DEVELOPMENT REVIEW BOARD REPORT

IYA Medical ASC/Imaging Center 21-DR-2021	Request for approval of exterior modifications to a portion of an existing multi-tenant building to account for a new 9,917 square foot medical office at +/- 1.6-acre site.

21-DR-2021

02 **NORTH ELEVATION**
SCALE: 1/8" = 1'-0"

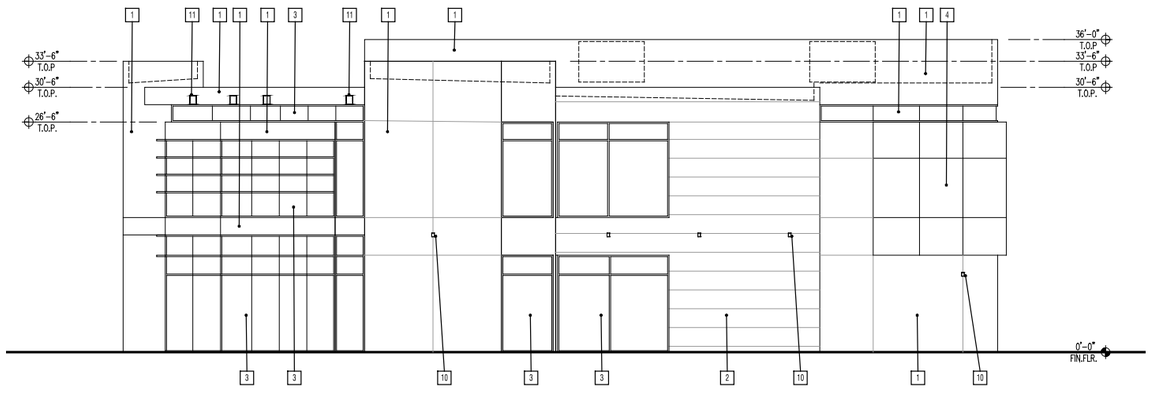
- *The proposed scope does include an integrated art panel on the north elevation of the building. That component is identified to be etched glass paneling with an edge-lit illumination system. The staff recommended stipulations include parameters for operating that illumination at minimal levels to create the desired highlight effect to the etched design without excessive light trespass.*

6. The Glass Art Panels shall be limited to etched/sandblasted clear glass panels with monochromatic tones. If illuminated, the panels shall be edge-lit from the perimeter edges with controllable LED lighting mounted within aluminum glazing channels. The illumination output of the panels shall be limited to the minimum levels necessary to highlight the etching but minimize light trespass beyond the panel face. The final installed and operated illumination levels shall be maintained to the satisfaction of City staff.
